TR18-100-102

14. Treatment of cuttings at Tolmans Hill, Hobart

Figure 19.

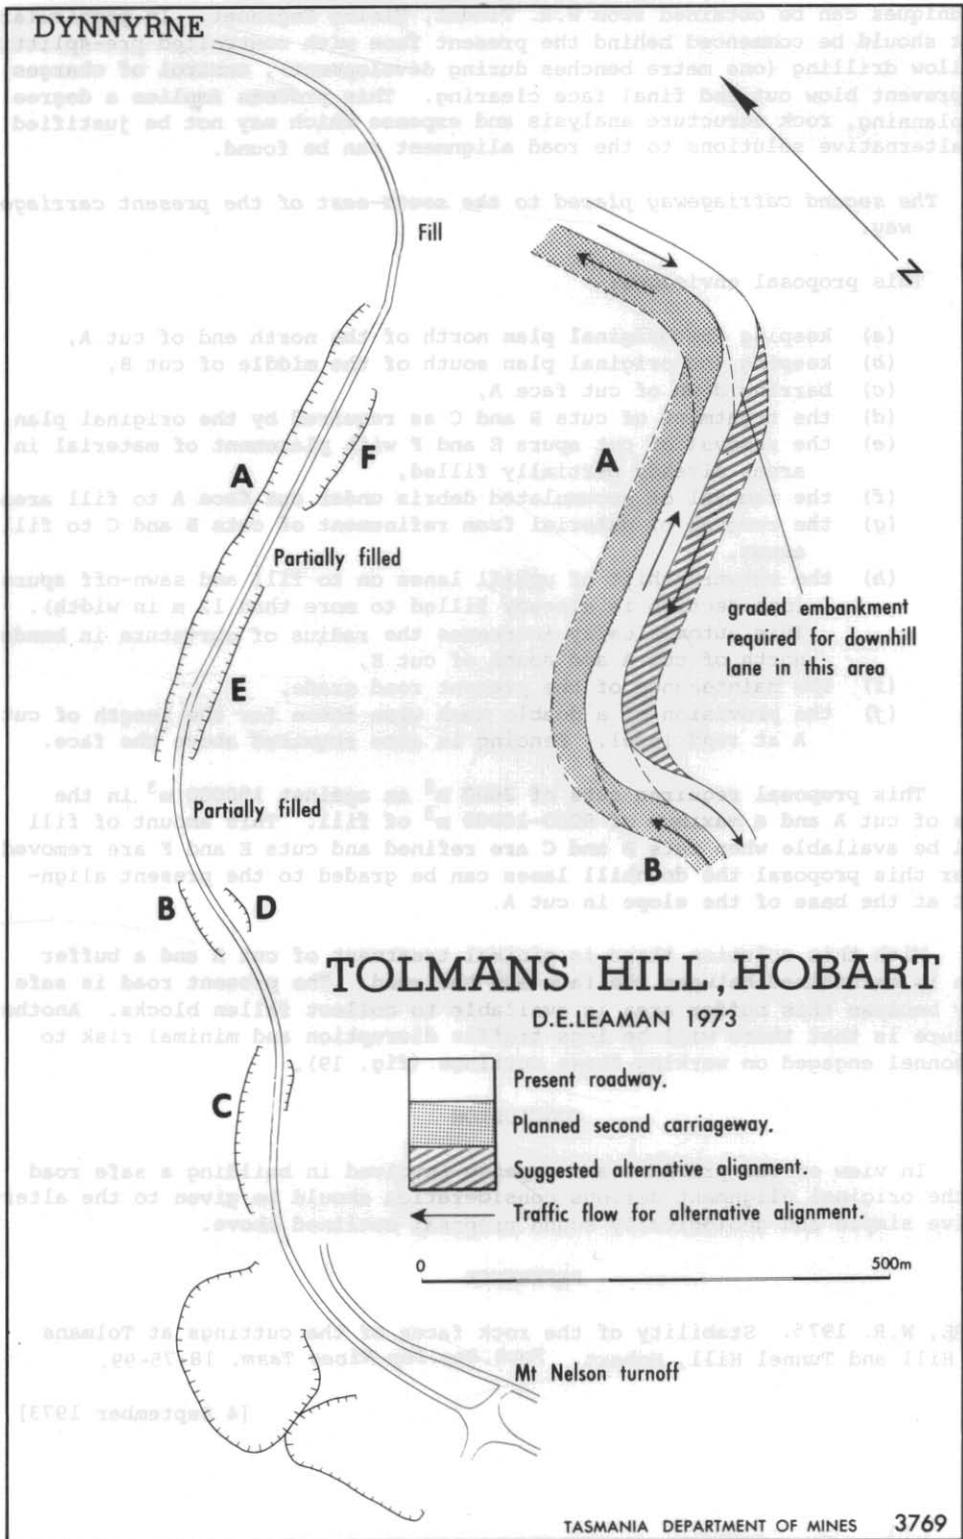
- (a) keeping the original plan north of the north end of cut A,
- (b) keeping the original plan south of the middle of cut B,
- (c) barring down of cut face A,
- (d) the treatment of cuts B and C as required by the original plan,
- (e) the removal of cut spurs E and F with placement of material in areas already partially filled,
- (f) the removal of accumulated debris under cut face A to fill area,
- (g) the removal of material from refinement of cuts B and C to fill areas,
- (h) the outward shift of uphill lanes on to fill and sawn-off spurs (one section is already filled to more than 12 m in width). This automatically increases the radius of curvature in bends north of cut A and south of cut E,
- (i) the maintenance of the present road grade,
- (j) the provision of a double mesh wire fence for the length of cut A at road level. Fencing is also required above the face.

This proposal requires cuts of 2600 m<sup>3</sup> as against 150000 m<sup>3</sup> in the area of cut A and a maximum of 8000-10000 m<sup>3</sup> of fill. This amount of fill will be available when cuts B and C are refined and cuts E and F are removed. Under this proposal the downhill lanes can be graded to the present alignment at the base of the slope in cut A.

With this solution there is minimal treatment of cut A and a buffer zone is maintained between the face and the road. The present road is safe only because this buffer area is available to collect fallen blocks. Another feature is that there will be less traffic disruption and minimal risk to personnel engaged on working these cuttings (fig. 19).

In view of the problems and expense involved in building a safe road on the original alignment serious consideration should be given to the alternative simple and geologically sound proposal outlined above.
